Access Compliance Report

Public Rights-of-Way

Intersection ID: 42724	Main Street: SPEEDWELL_CT	Cross Street: WAKEROBIN_LN	Location: W
ADA ID: 5EAD939A2C85	Ramp Type: PerpDiag	Initial Pass/Fail: Fail	Overall Compliance: No
Severity Score: 18.75			
Codes/Mitigation Info/Possible Solution		Field Measurements/Component Compliance

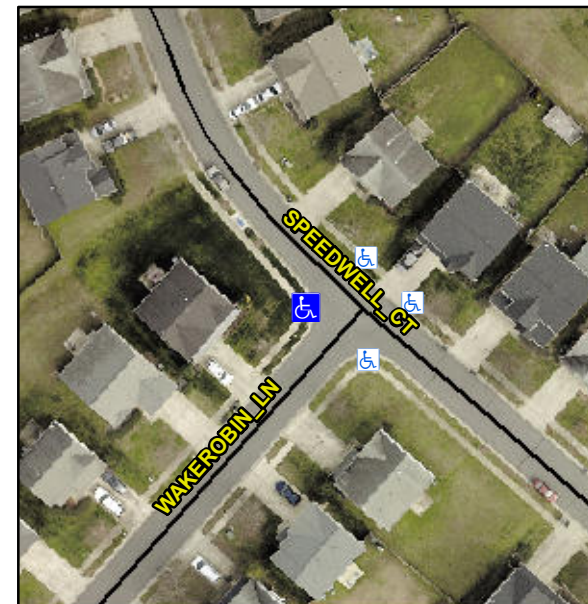
Not Found, R304.5.1, R304.5.3

Compliance	Description	Data	Compliance	Description	Data
N/A	Ramp Length (in)	48.0	Yes	Ramp Slope (%)	5.5
No	Ramp Width (in)	35.0	No	Ramp XSlope (%)	3.7
N/A	Flare Type LT	N/A	N/A	Flare Type RT	N/A
N/A	Flare Slope LT (%)	N/A	N/A	Flare Slope RT (%)	N/A
N/A	Flare Traversable LT?	N/A	N/A	Flare Traversable RT?	N/A
N/A	Landing Length (in)	N/A	N/A	DWS Provided?	N/A
N/A	Landing Width (in)	N/A	N/A	DWS Contrast?	N/A
N/A	Landing Slope (%)	N/A	N/A	DWS Length (in)	N/A
N/A	Landing X Slope (%)	N/A	N/A	DWS Full Width?	N/A
N/A	Landing Curb? (Y/N)	N/A	N/A	DWS Offset (in)	N/A
N/A	Shared Landing?	N/A			
N/A	Gutter Ponding?	N/A	N/A	Gutter Slope (%)	N/A
N/A	Gutter Lip Ht (in)	N/A	N/A	Gutter X Slope (%)	N/A
N/A	Painted X Walk1?	No	N/A	Painted X Walk2?	No
	X Walk 1 Direction	To SE		X Walk 2 Direction	To NE
N/A	X Walk 1 Width (in)	N/A	N/A	X Walk 2 Width (in)	N/A
	X Walk 1 Slope (%)	1.9		X Walk 2 Slope (%)	4.1
	X Walk 1 X Slope (%)	4.4		X Walk 2 X Slope (%)	4.9

Remove & Replace Curb Ramp With Two New Directional Ramps or Equivalent.
